SUBMITTAL TO THE BOARD OF DIRECTORS OF THE  
REDEVELOPMENT AGENCY  
COUNTY OF RIVERSIDE, STATE OF CALIFORNIA

SUBJECT: Cabazon Civic Center – Award of Construction Contract

During the advertisement period, five (5) addenda were issued to the specifications for the project. Bidders are required to acknowledge and take into account all issued addenda on their bid proposal to be considered for award. The addenda were issued to clarify and modify the approved project contract documents. The addenda are attached.

**PG1** CABAZON CDC INFANT & TODDLER AREA  
PLAYGROUND PLAN (N.T.S.)

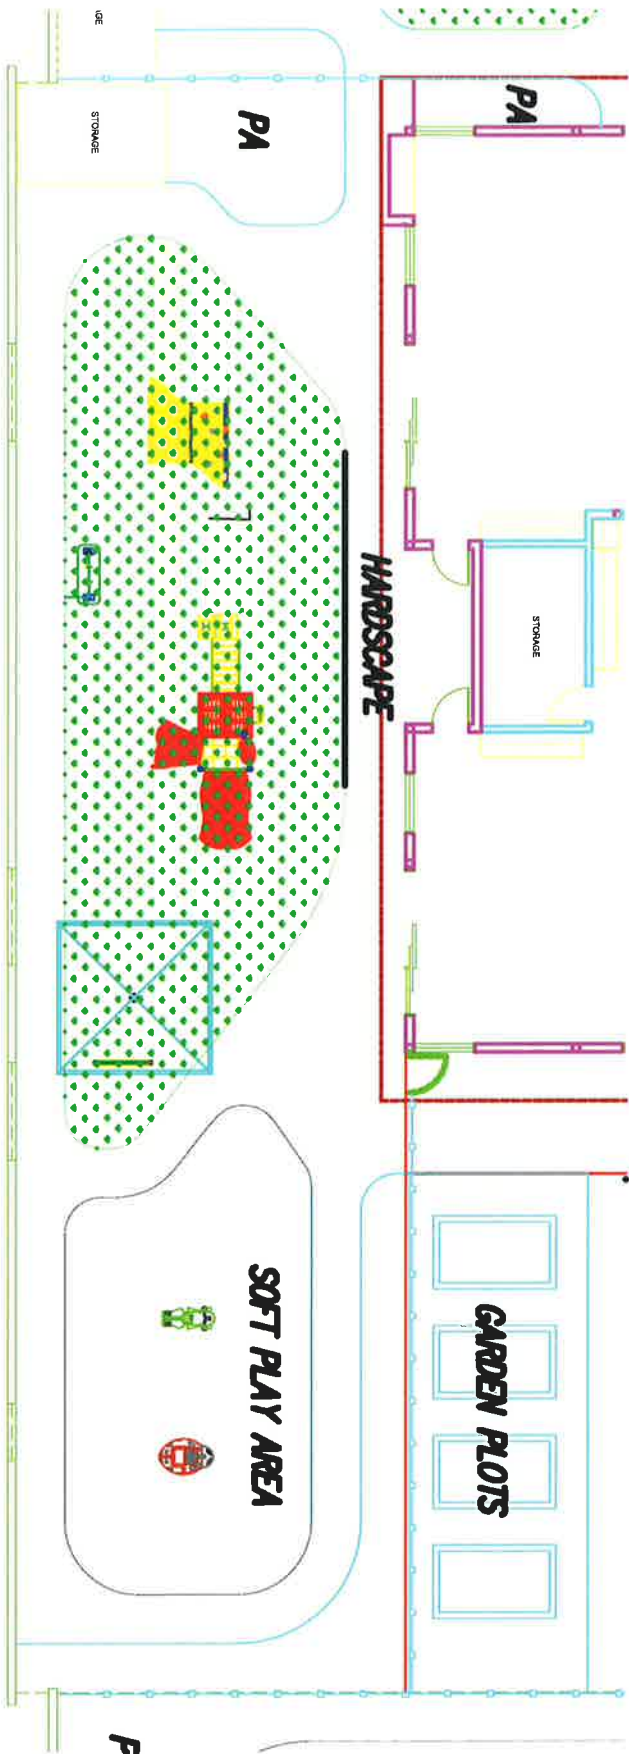
1. Site Package: Construction Plan - Sheet L-3: see attachment #11 to this Addendum for referenced playground equipment layout by Kaplan Early Learning Co.
2. Site Package: Sheets L-6 and AS-02: the layout for the Tot Lot (C/L-6) is correct; this information supersedes that shown in the same location on AS-02.
3. Library – Package B: missing Sheet PS-02 is identical to Sheet PS-02 in Family Service Administration Building – Package A.

CON STD 104 &  
CON STD 207A

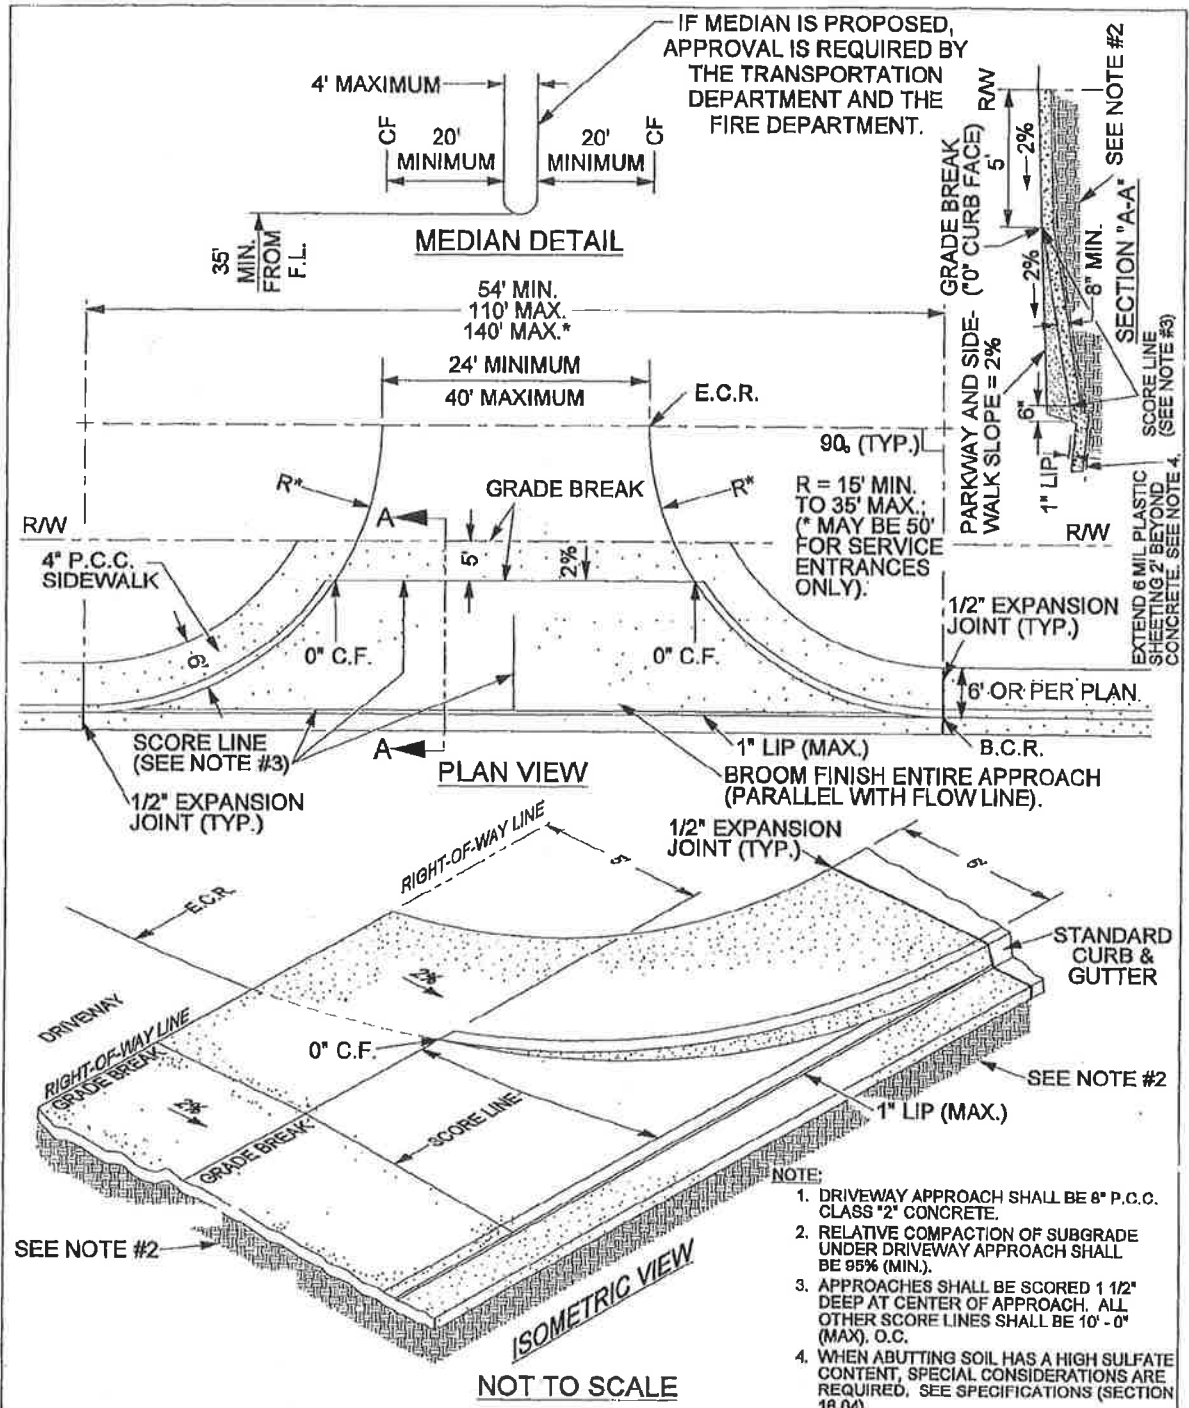
Request: Reference Sheet C9.103 - Carmen Ave.

Response From: Bill Brooks, P.E.
